**EXTRAORDINARY COUNCIL/TE KAUNIHERA**  
DATE: Wednesday 6 November 2024  
TIME: 9:00AM  
AT: Te Ruma Kaunihera (Council Meeting Room), Awarua, Fitzherbert Street, Gisborne

- 1. Apologies .....3
- 2. Declarations of Interest.....3
- 3. Leave of Absence .....4
- 4. Acknowledgements and Tributes .....4
- 5. Public Input and Petitions .....4
- 6. Extraordinary Business .....4
- 7. Notices of Motion .....4
- 8. Adjourned Business.....4
- 9. Reports of the Chief Executive and Staff for DECISION .....5
  - 9.1. **24-314** Proposed changes to Grey St / Kahutia St Intersection .....5

The Streets for People project seeks to primarily enhance cyclist safety on Grey Street in Gisborne by implementing protected cycling facilities. Safety improvements for pedestrians are also included through additional pedestrian crossings. Associated traffic calming measures on Grey Street and at vehicle accesses, along with the associated road markings and traffic signs, are also introduced. The extent of the works is from Grey Street/Childers Road intersection to 130 m west of Grey Street/Kahutia Street intersection, as shown in Figure 3.1-1.

Figure 4.4-3 – Car driving across the cycleway and turning left onto Kahutia Street (2)

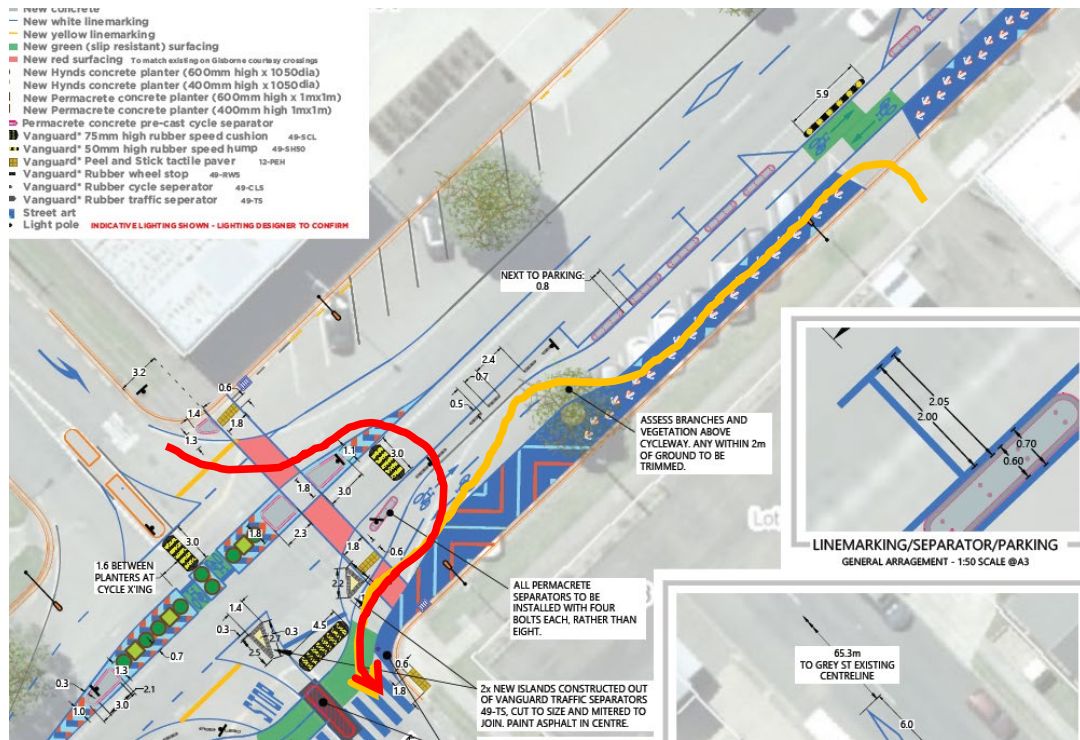
- A car turned left out of the AA centre, drove along the cycle lane, around the tree and turned left into Kahutia Street (E). This movement is shown in orange colour in Figure 4.4-1;
- A car turned left out of Kahutia Street (W) onto Grey Street, performed a U-turn after the central kerbed island, drove through the cycleway and artwork pavement markings and turned into Kahutia Street (E). This movement is shown in red colour in Figure 4.4-1;
- A delivery vehicle drove through the cycleway and parked over the artwork pavement markings on the southern side of the Grey Street/Kahutia Street intersection.

<b>Probability Rating:</b>	<b>Severity Outcome Rating:</b>
<b>The probability of a crash is Likely</b>	<b>Crashes are likely to be Serious</b>
<p><b>Design Team Response:</b> <i>The design included a bollard between the cycling and pedestrian spaces on each side of Kahuita Street to try and prevent these sorts of movements. I understand this was not installed due to late changes which enabled some elements to be mountable by trucks. Earlier versions of the design included concrete seperators on Grey Street east of the intersection, which were subsequently cost-cut to the very minimal rubber seperators in the space there now, which clearly don't prevent vehicles crossing. Our suggestion – replace the rubber seperators east of Kahutia on Grey Street with more substantial, preferably concrete.</i></p>	
<p><b>Safety Engineer:</b> <i>Agree. The environment should be managed with infrastructure provided to: protect vulnerable road users and / or prevent unintended vehicle manoeuvres which may compromise safety.</i></p>

Figure 4.4-7 – Wheel tracks on the berm and footpath

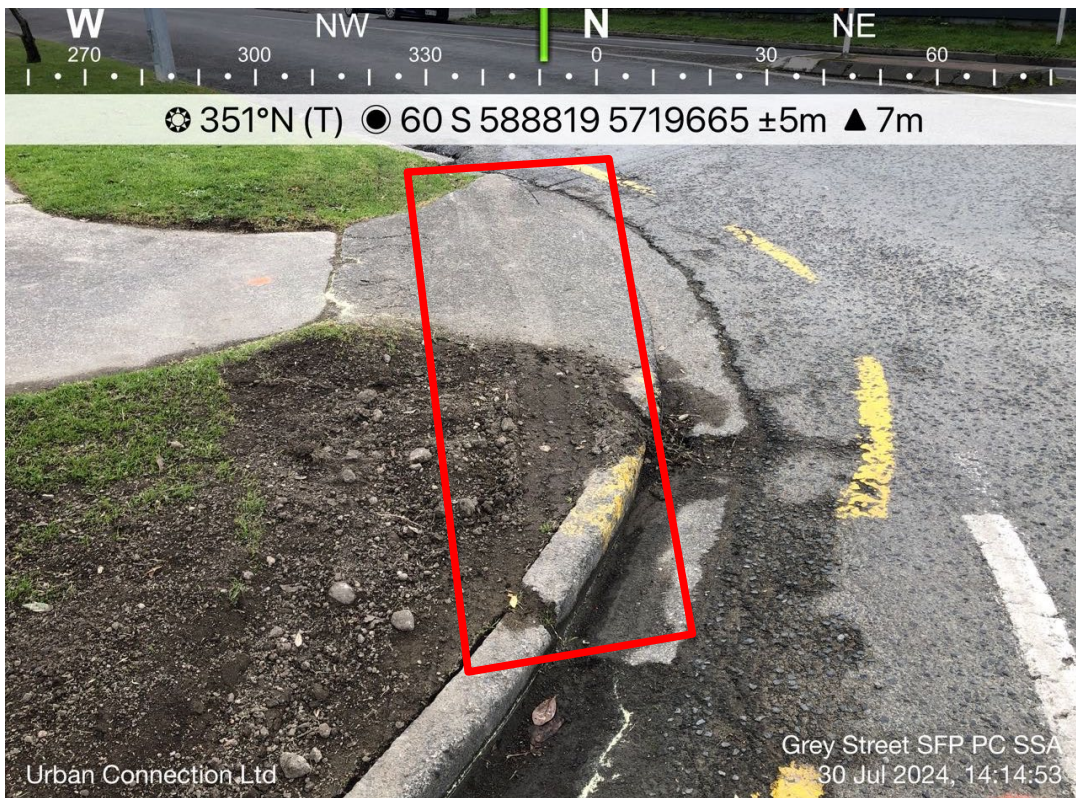
The design provides vehicle tracking for a large rigid truck (11.5 m long), indicating that the movements undertaken by these vehicles are appropriately accommodated at the Grey Street/Kahutia Street intersection. However, the auditors observed evidence (wheel tracks) that heavy vehicles were going over the kerb and encroaching on the berm/footpath when undertaking a left turn onto Kahutia Street (W), as shown in Figure 4.4-7.

<b>Probability Rating:</b>	<b>Severity Outcome Rating:</b>
<b>The probability of a crash is Very Unlikely</b>	<b>Crashes are likely to be Serious</b>
<p><b>Design Team Response:</b> As can be seen in Google Streetview imagery, most that dated July 2019, this is a pre-existing issue, however, potentially the over-run may have become more frequent since the modal filter was installed. This project was designed to accommodate the RTS18 Large Rigid Truck as the design vehicle, however it has become evident that larger vehicles make movements into and out of Kahutia Street semi-regularly. We recommend investigation into what demand there is for larger vehicles, which movements, and whether there are alternative reasonable routes some of these particularly large vehicles can take which do not pass through this key urban area. For remaining movements, we suggest adjustments to the design to accommodate the RTS18 Semi Truck, such as localised changes to kerblines and/or removal/adjustment of some islands. with careful consideration and mitigation of effects on safety and amenity for all other users.</p>

Figure 4.4-23 – Electronic Billboard/Sign

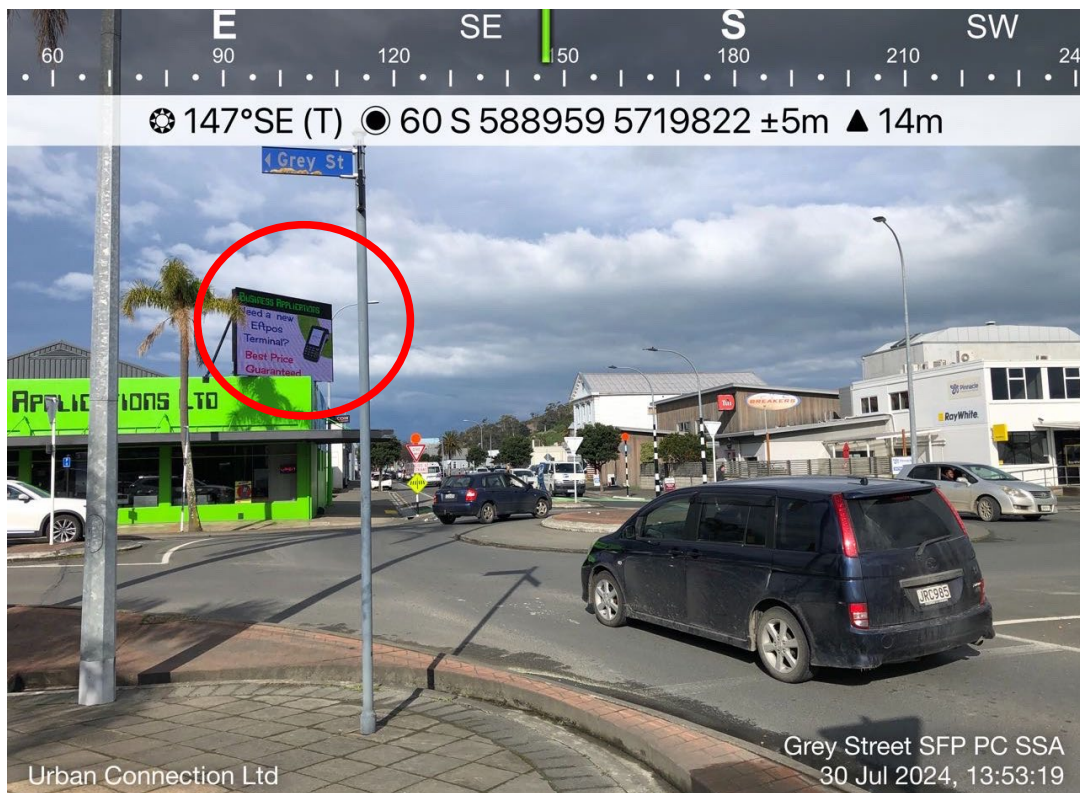
- They are located close to an intersection, merging or diverging traffic sites or other sites where demands on motorists' concentration is high;
- Each separate display is not static from the first appearance to replacement;
- The time to change from one display to the next is greater than two seconds;
- The minimum time for any separate display is less than five seconds.

1. Consider relocating the electronic sign away from the zebra crossing or provide an electronic billboard in accordance with TCD rules.

<b>Probability Rating:</b>	<b>Severity Outcome Rating:</b>
<b>The probability of a crash is Unlikely</b>	<b>Crashes are likely to be Serious</b>
<b>Design Team Response:</b> <i>This issue is outside of the scope of this project, and it is recommended for consideration by GDC</i>	
<b>Safety Engineer:</b> <i>Agree. Distractions to drivers should be avoided at key decision points where there is the risk of serious injury; especially vulnerable road users such as pedestrians and cyclists.</i>	
<b>Client Decision:</b> <i>This was an existing crossing point with the obstruction in place without being under the control of a zebra crossing</i>	
<b>Action Taken:</b> <i>No action taken</i>

**Figure 4.4-42 – Low-level light not working on Childers Road**

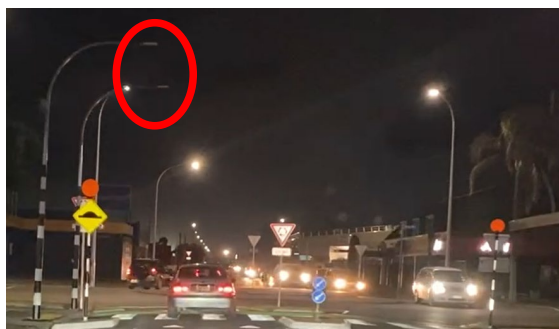
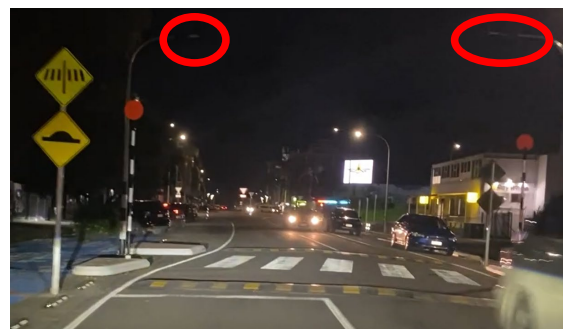
It is understood that lighting installation was being finalised at the time of the audit. This is, therefore, presented as a comment at this stage. However, it is important to highlight that the low-level lighting poles must be functional to improve lighting levels in the vicinity of the pedestrian crossings.

<b>Probability Rating:</b>		<b>Severity Outcome Rating:</b>	
The probability of a crash is N/A		Crashes are likely to be N/A	
<b>Design Team Response:</b> This is for GDC to investigate.			
<b>Safety Engineer:</b>		Agree that lighting should be installed and operating as intended, especially for pedestrian safety.	
<b>Client Decision:</b>		Eastland Network were still processing the application to turn the new lights on during the safety audit.	
<b>Action Taken:</b>		The lights are now active
